6 September 2019
Ref 18482

**PROPOSED HOTEL DEVELOPMENT
301-305 KENT STREET, SYDNEY
TRAFFIC AND PARKING MATTERS
SSD 9694**

I refer to the Transport for NSW letter dated 3 July 2019 requesting additional information in respect of the above-mentioned development proposal.

Figure 2: Hourly Pedestrian Volumes

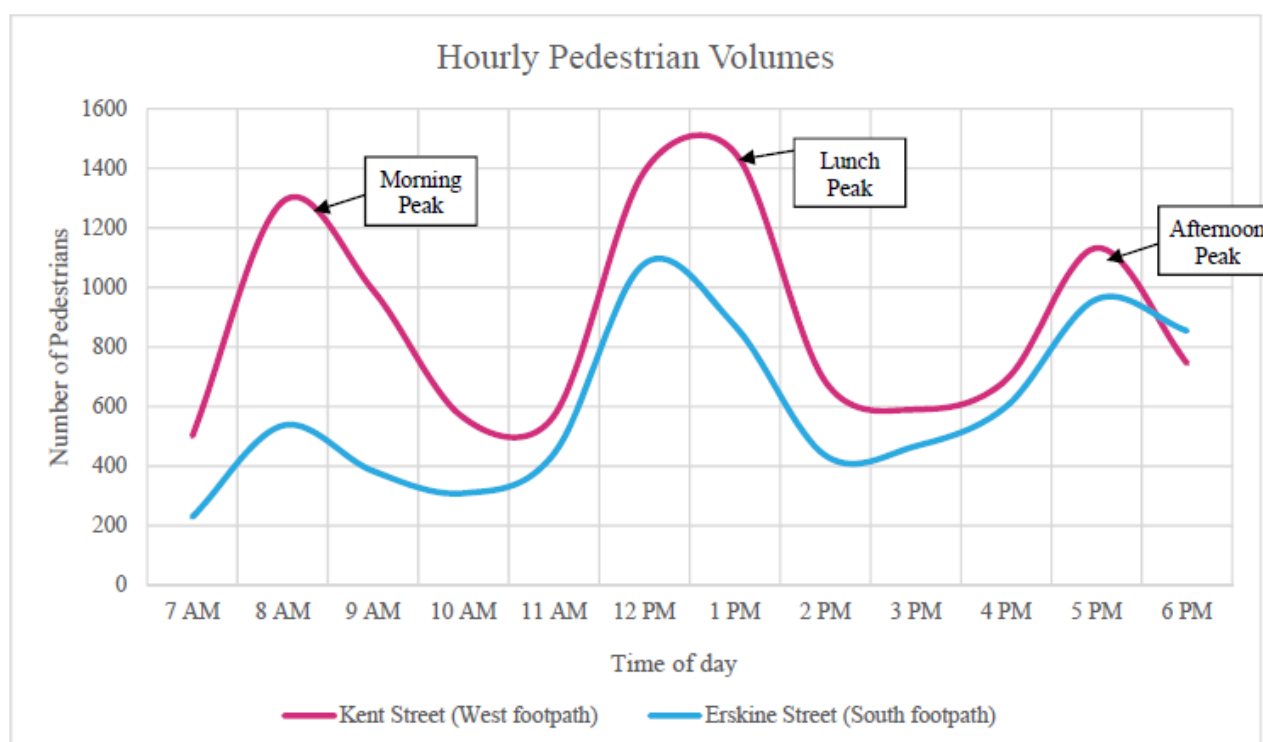
Figure 2 of 2 of the *Arup* report compares the hourly pedestrian volumes along the Kent Street and Erskine Street frontages of the site, and clearly demonstrates that pedestrian activity along the Kent Street footpath is significantly *higher* than pedestrian activity along the Erskine Street footpath.

As shown in Figure 2, the pedestrian volume on Erskine Street was found to be consistently less throughout the day compared with Kent Street, particularly in the morning and lunch peak hours. Therefore a driveway access on Erskine Street serving the hotel would result in significantly less conflicts between pedestrians and vehicles throughout the day when compared to Kent Street. Thus, Erskine Street presents itself as a better alternative for the location of the driveway.

Figure 3: Erskine Street Pedestrian Volumes

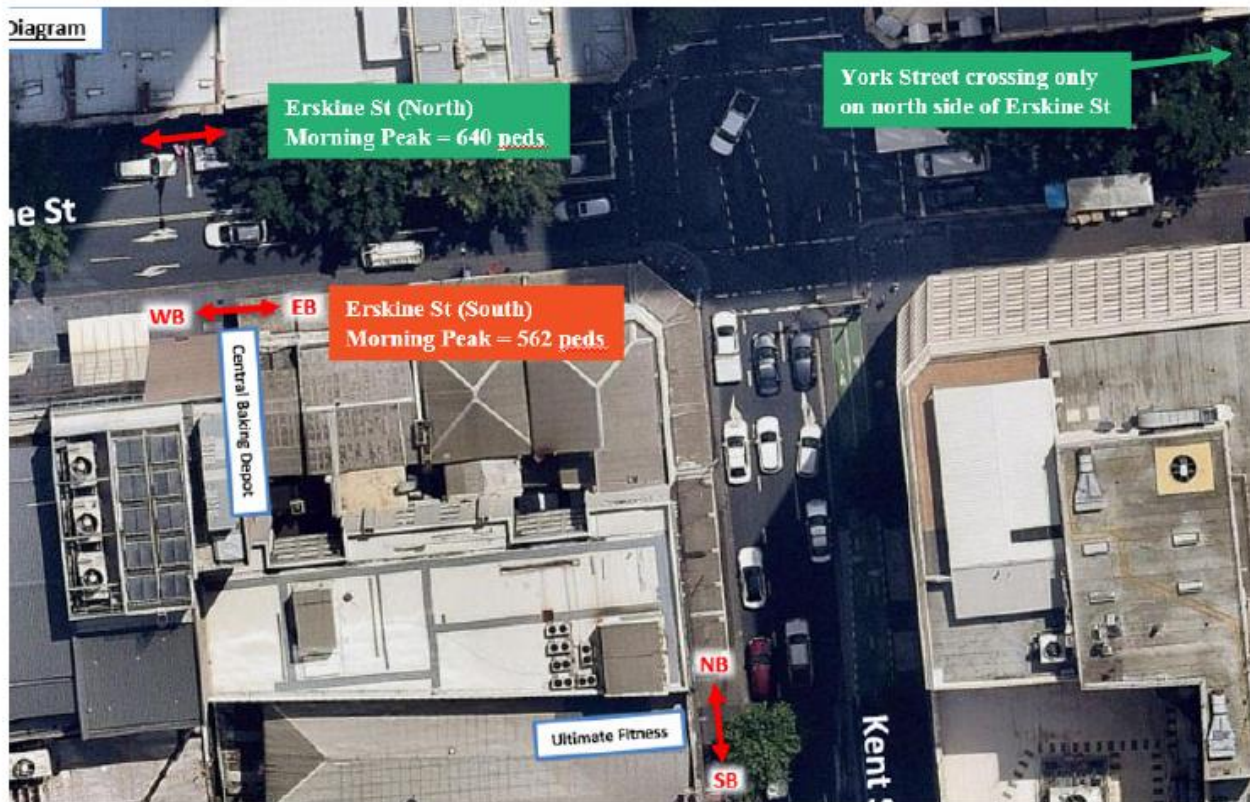
As shown in Table 1, Erskine Street North was observed to have a greater number of pedestrians than Erskine Street South. It is expected that this is in part due to the fact that there is no pedestrian crossing available on the south side of the Erskine Street/ York Street intersection. This is shown in Figure 3.

As pedestrians are already observed to prefer to walk along the north side of Erskine Street, it is expected that the access driveway on the south side of the road would not negatively impact pedestrian movement.

Erskine Street & Site Access Driveway Intersection

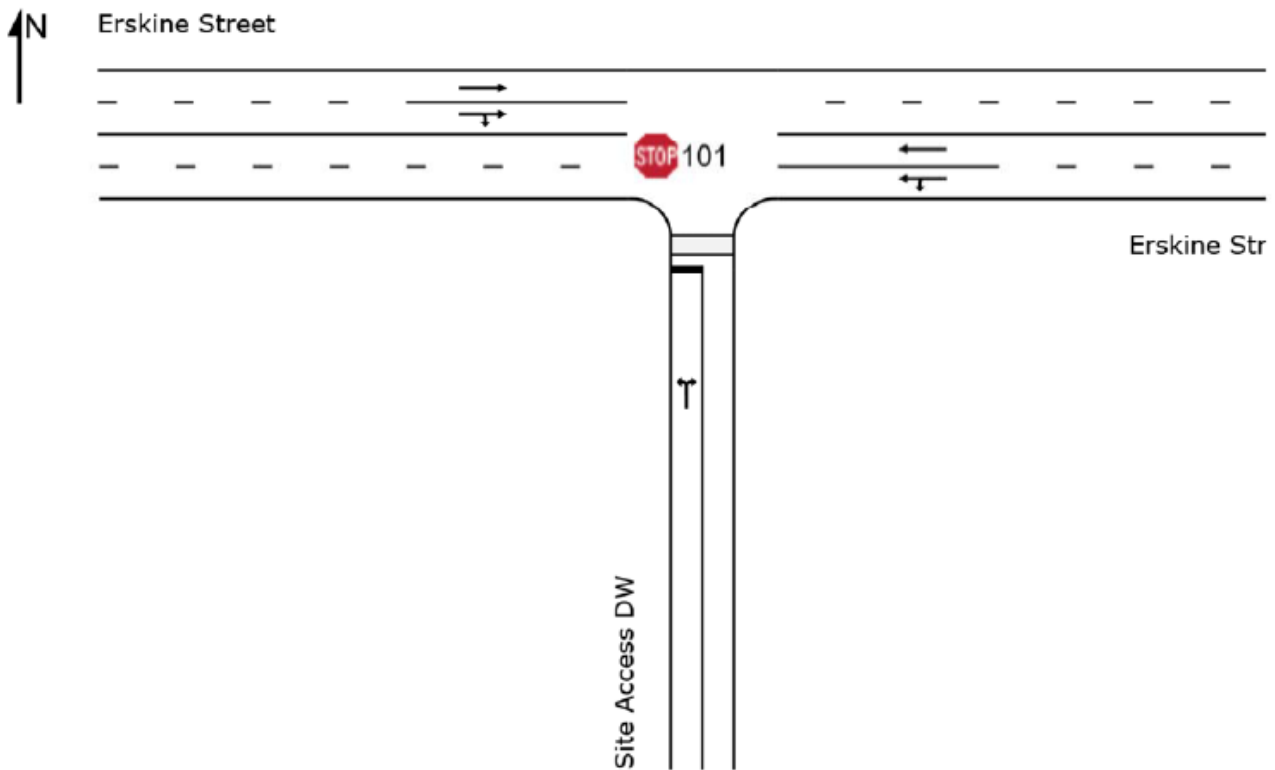
VTP Pty Ltd also undertook an analysis of the proposed driveway, using the SIDRA capacity analysis program. The results of that analysis are summarised in table 1 below and the detailed “Movement Summaries” area attached, revealing that:

- in the AM peak the 98th percentile queue in the left lane of Erskine Street would be 0.3 vehicles waiting for pedestrians to pass prior to entering the driveway, and
- in the PM peak the 98th percentile queue in the left lane of Erskine Street would be 0.4 vehicles waiting for pedestrians to pass prior to entering the driveway.

In summary, the capacity analysis demonstrates that the 98th percentile queue length (i.e. which occurs only 2% of the time) at the proposed driveway would be *less than half a vehicle*, and that any momentary queues would be well clear of the Kent Street/Erskine Street intersection which is located some 27m distance from the proposed driveway. As such, it is clear that traffic and bus operations would not be affected in any way by the proposed driveway.
